Permit Application Review Report
Date: 9/9/2026

Project Name: Viridian Sentinel

Project PAN: P-26-027

Project Purpose: new apartment complex and parking

Figure 3: Soil and Erosion Control Plan

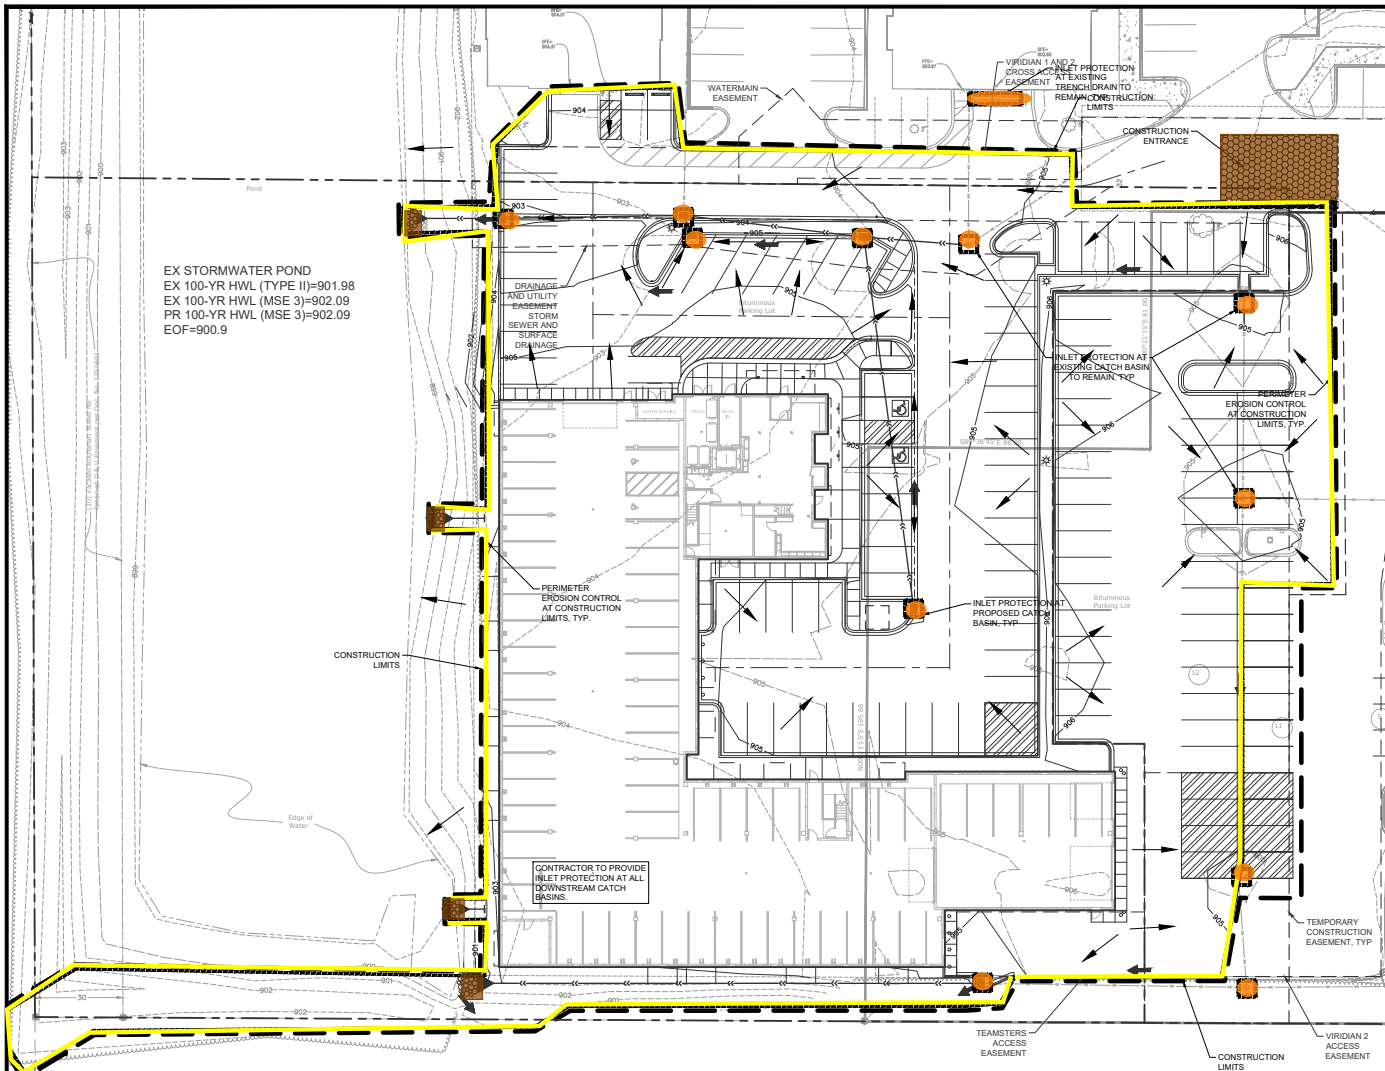
2. Update the SWPPP to stabilize soils and soil stockpiles within 24 hours of inactivity.

The proposed project drains to Springbrook Creek. The soil affected by the project is Markey and does not have a soil erodibility factor of 0.15 or greater. Disturbed areas are not proposed to be stabilized within 7 days, as required. The proposed erosion and sediment control plan includes perimeter control, stabilized construction entrance, inlet protection, and street sweeping. The erosion control plan does not meet District requirements because soils and soil stockpiles are not consistently proposed to be stabilized within 7 days of inactivity. The site does require an NPDES permit. See attached Figure 3: Soils and Erosion Control Plan.
